RSN:1594223 | PERMIT# 2021-2083670-LT

ADCA Remodel & Expansion

City of Aurora Building Division
Project: *ADCA Remodel and Expansion*
Address: *1444 S POTOMAC ST Unit 300*
Occupancy Group: *IBC B*
Construction Type: *IBC TYPE II-B SPK*
RSN: *1594223*
Permit: *2021-2083670-LT*

City of Aurora Building Division
Reviewed for Code Compliance
Approved as Noted: Y. Munoz
Date: Dec 16, 2021
2015 INTERNATIONAL CODES & 2020 NEC

1 Egress Plan
Level Three

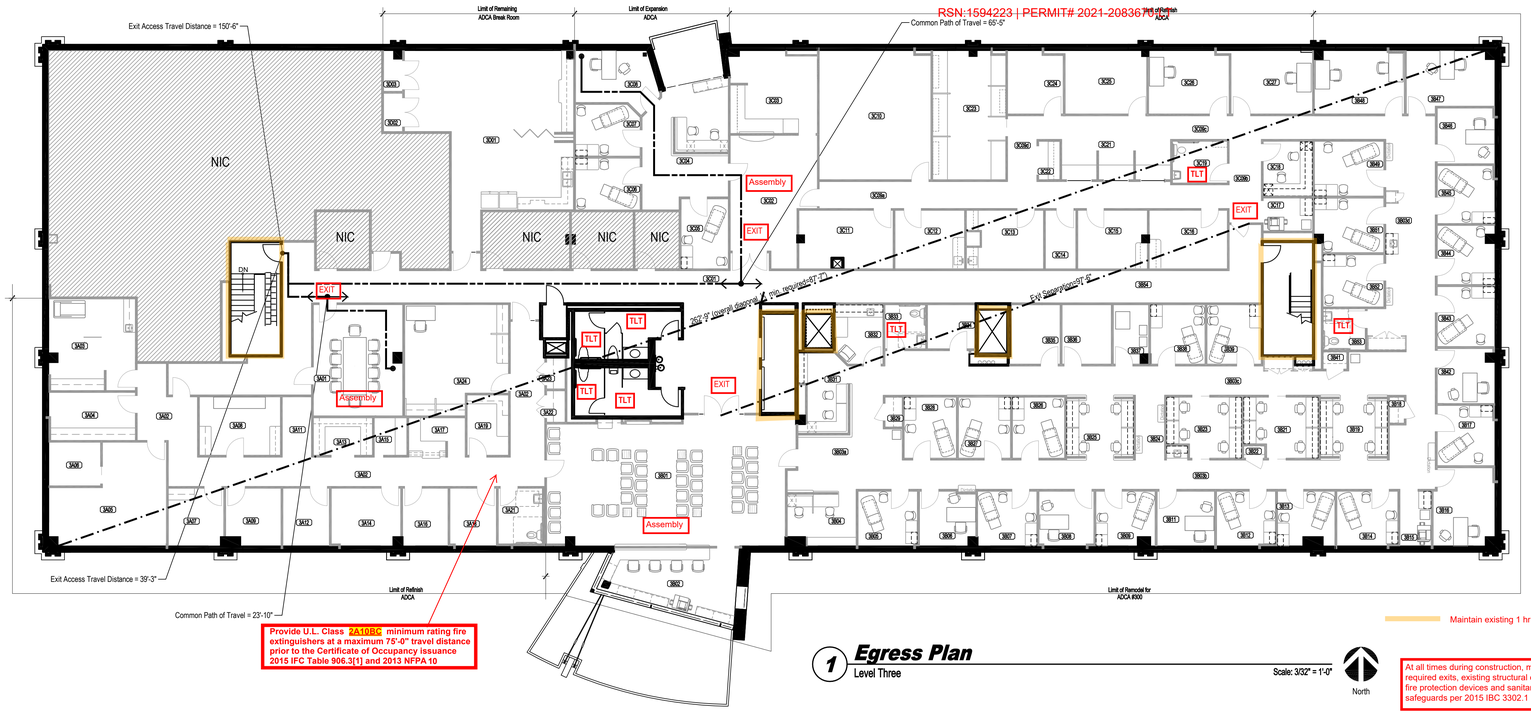
At all times during construction, maintain required exits, existing structural elements, fire protection devices and sanitary safeguards per 2015 IBC 3302.1

1 Demolition Plan
Suite 300

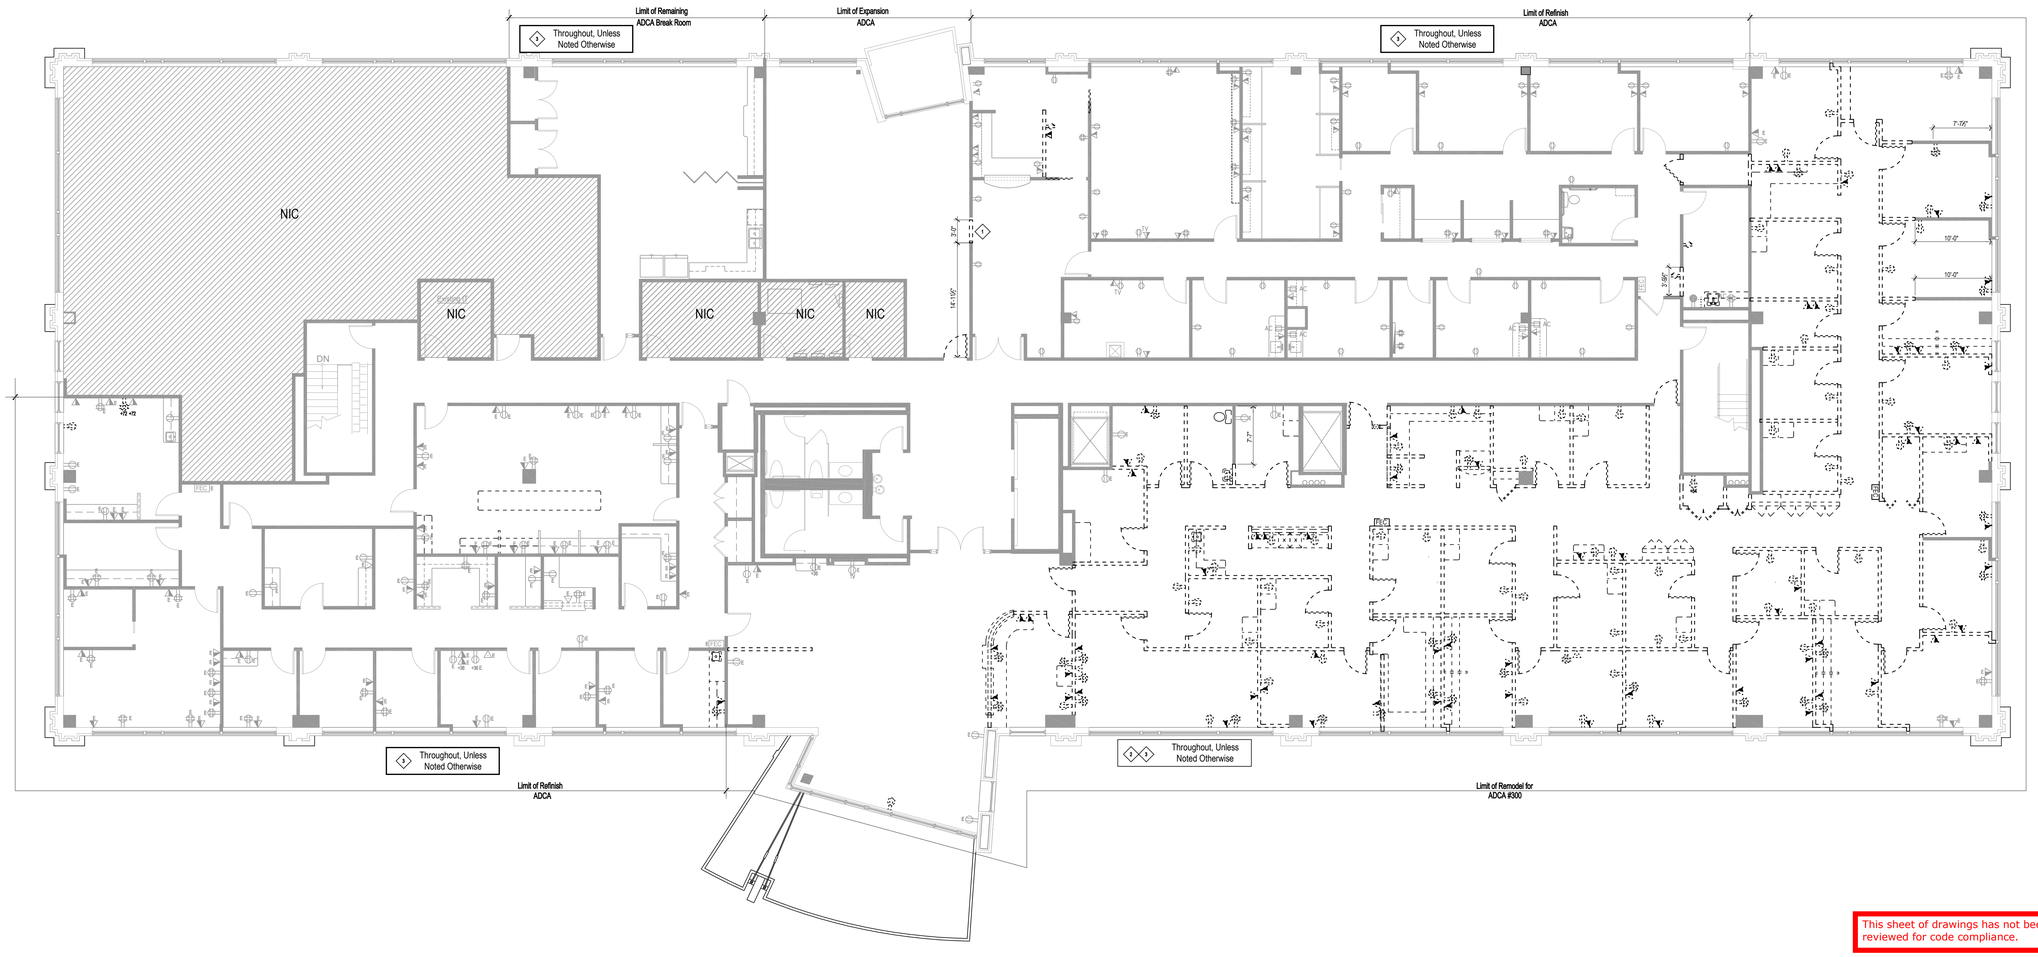
This sheet of drawings has not been reviewed for code compliance.

1 Demolition Ceiling Plan
Suite 300

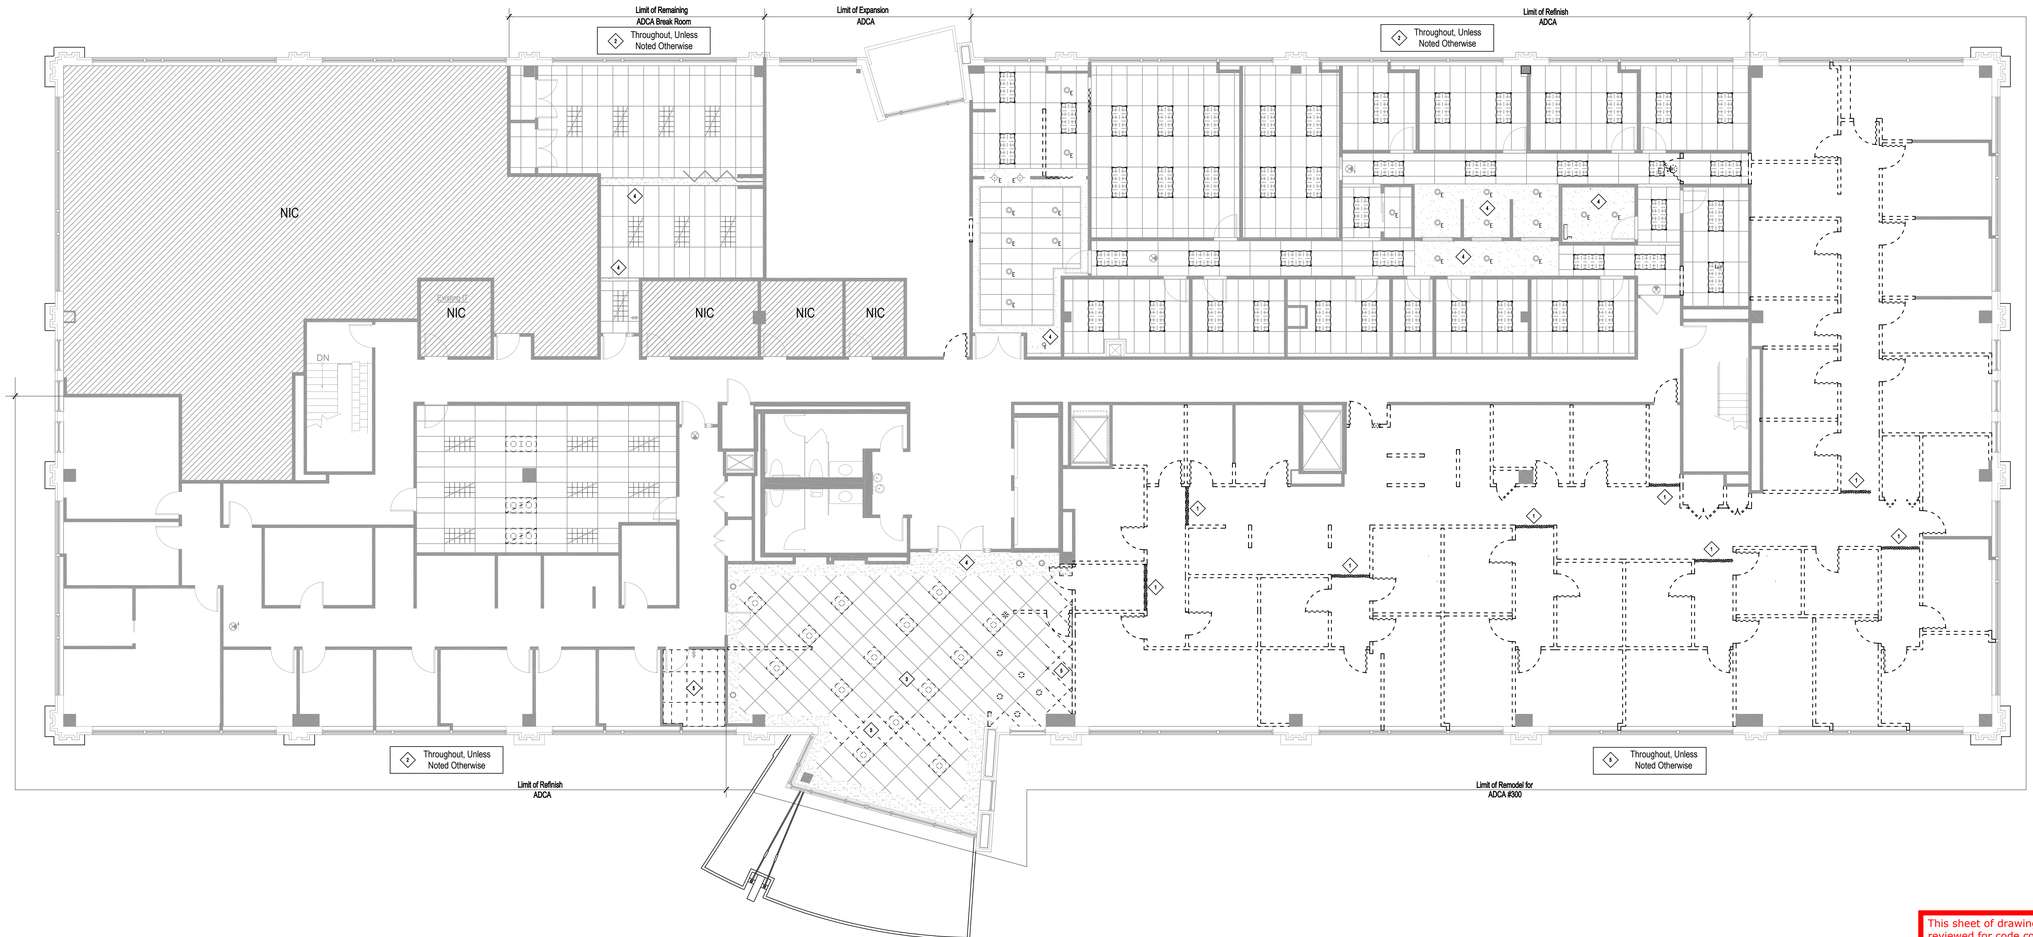
This sheet of drawings has not been reviewed for code compliance.

1 Construction Plan
Suite 300 — Scale: 1/8" = 1'-0"

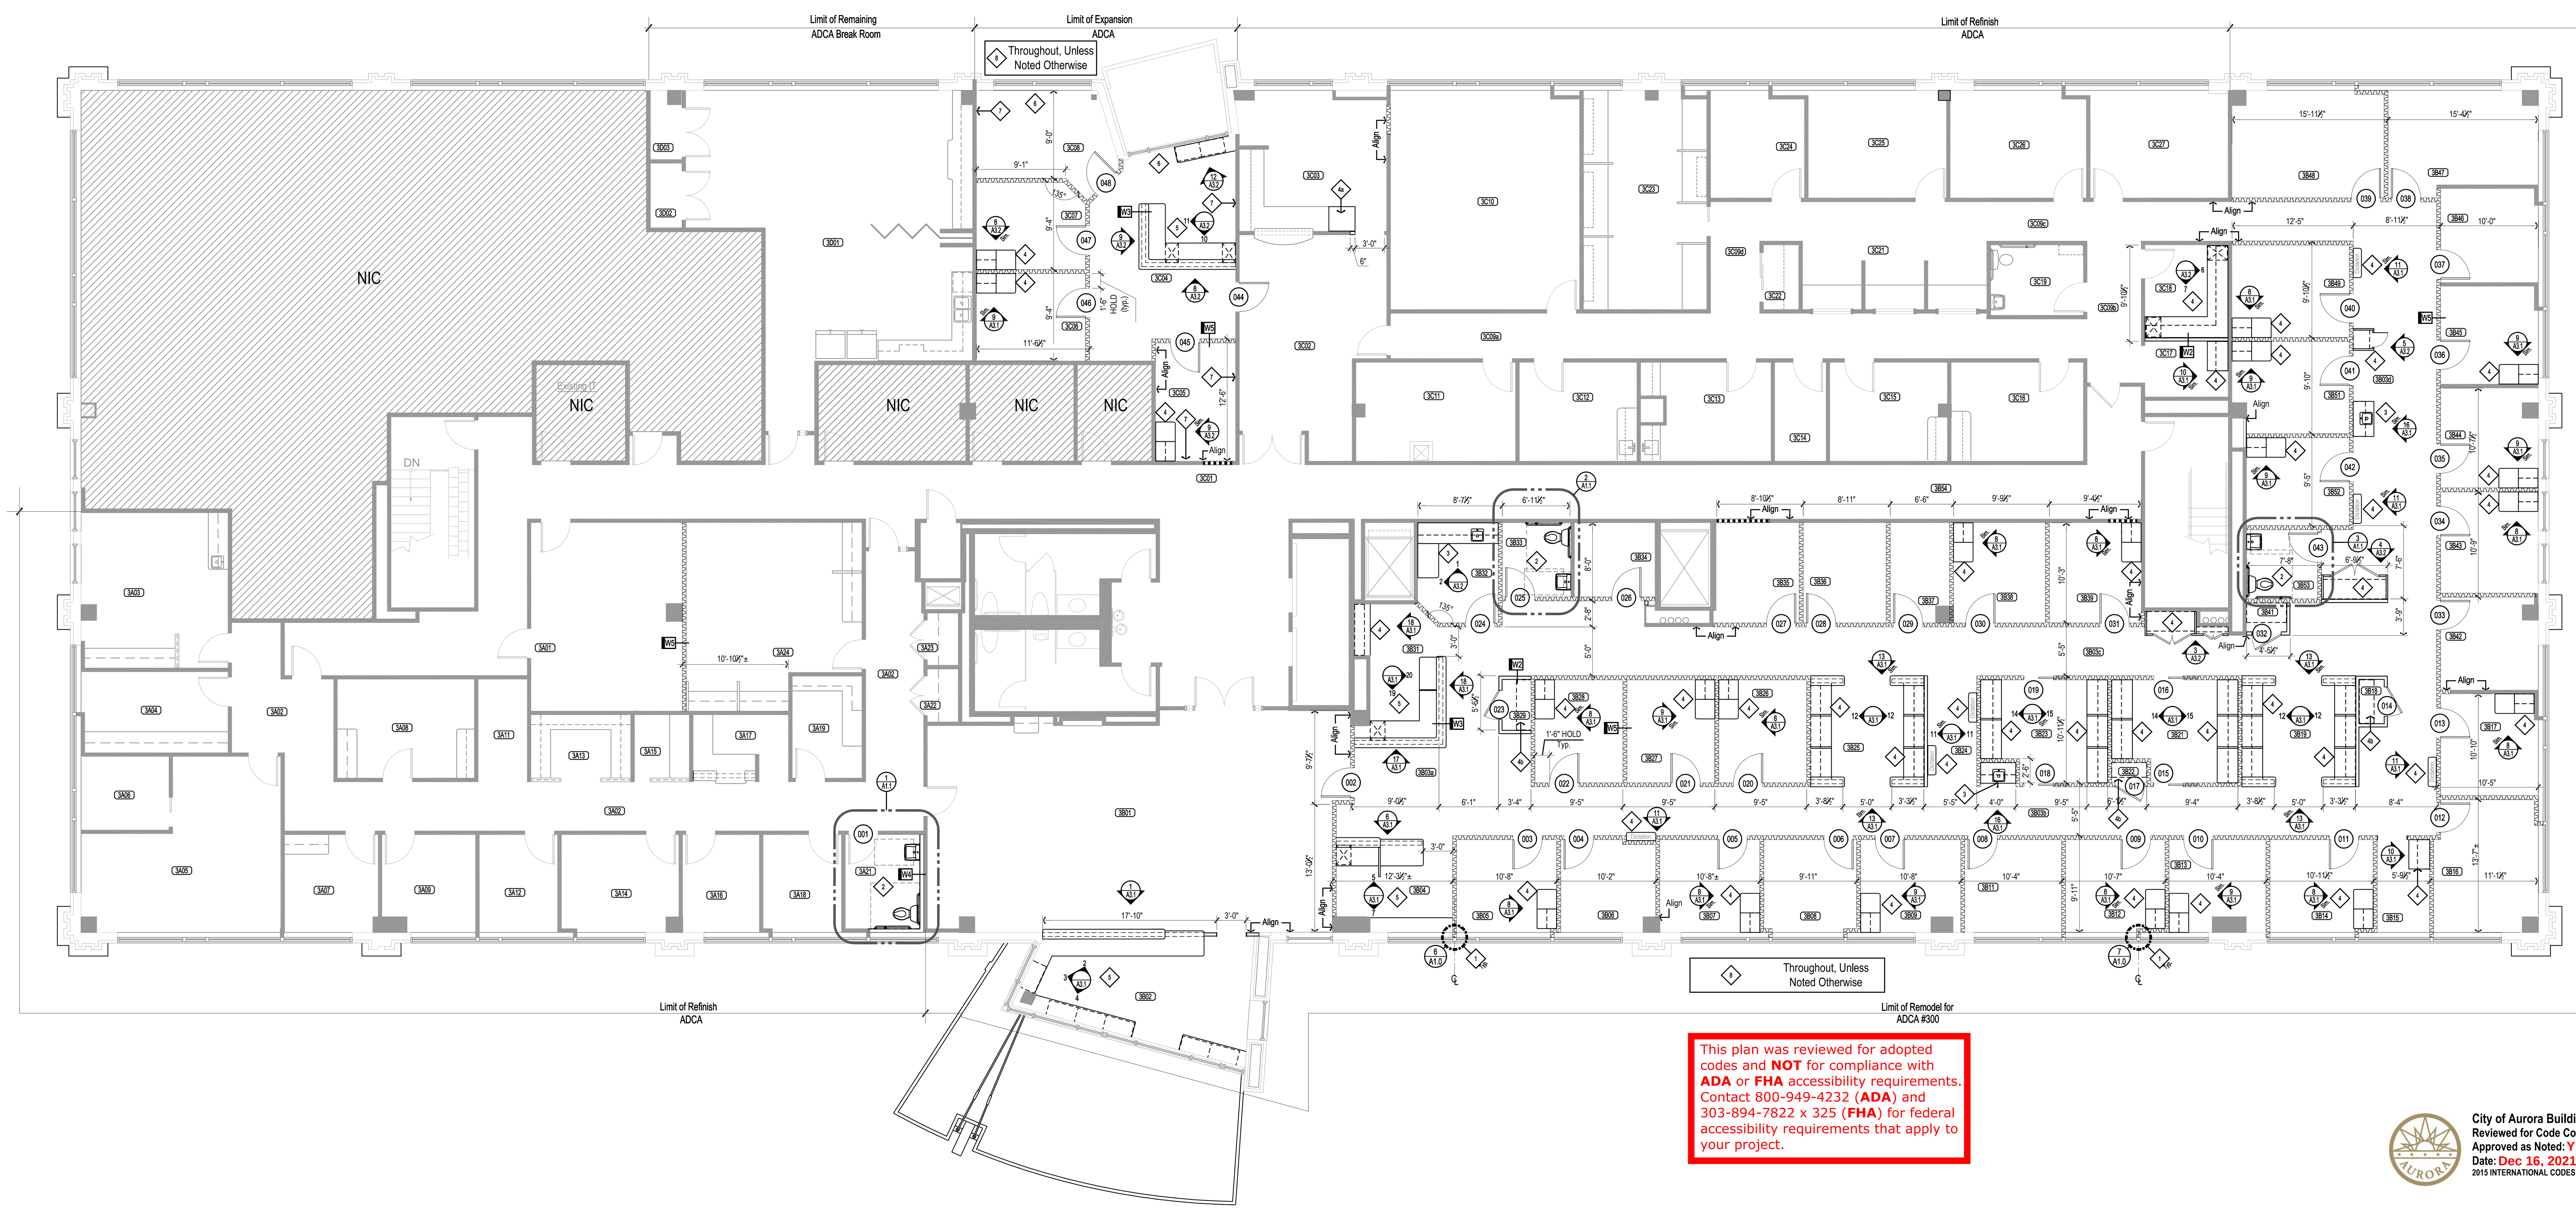
This plan was reviewed for adopted codes and **NOT** for compliance with **ADA** or **FHA** accessibility requirements. Contact 800-949-4232 (**ADA**) and 303-894-7822 x 325 (**FHA**) for federal accessibility requirements that apply to your project.

1 / M1.1 MECHANICAL PLAN
SCALE: 1/8" = 1'-0"

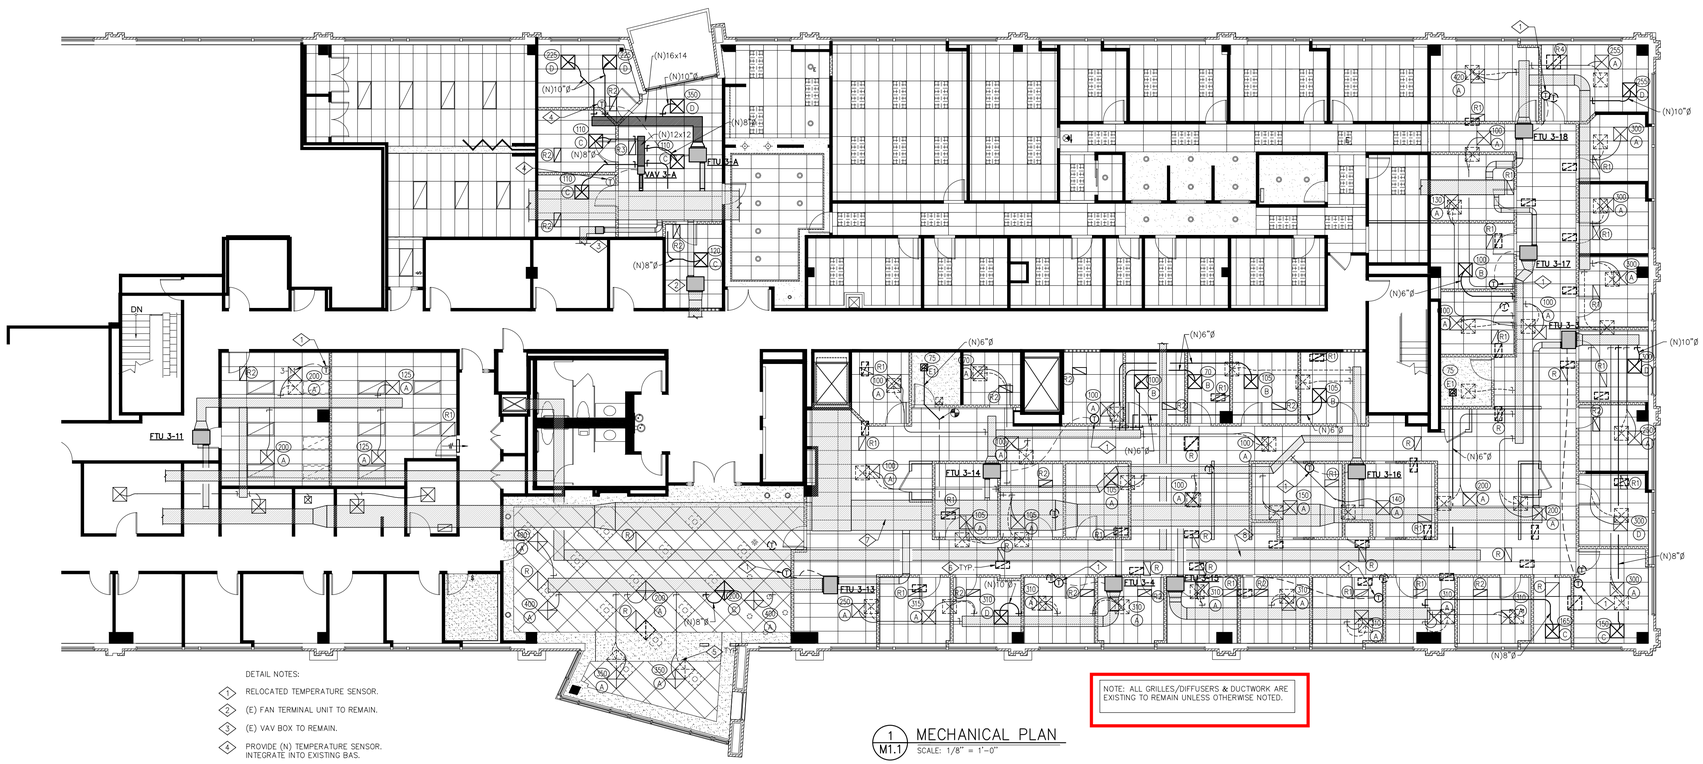
Provide proof of a flame spread less than 26 and a smoke development less than 50 for any material used in a plenum.
2015 IMC 602.2.1

1 P1.1 PLUMBING PLAN
SCALE: 1/8" = 1'-0"

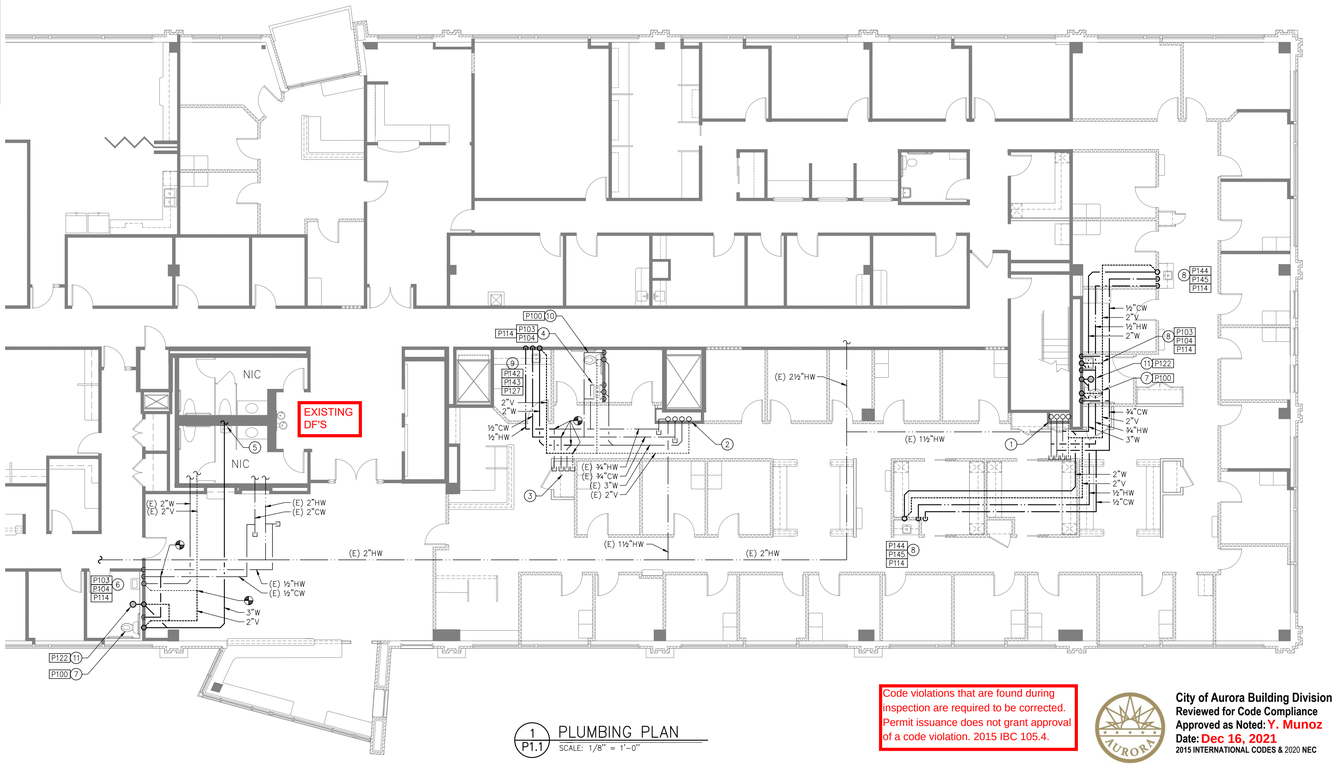
The dry vent must rise 6" vertically above the flood level rim of the highest trapped fixture being vented.
2015 IPC 905.4

Provide drains no smaller than allowed by **2015 IPC 709.1 and 710.1(1)**
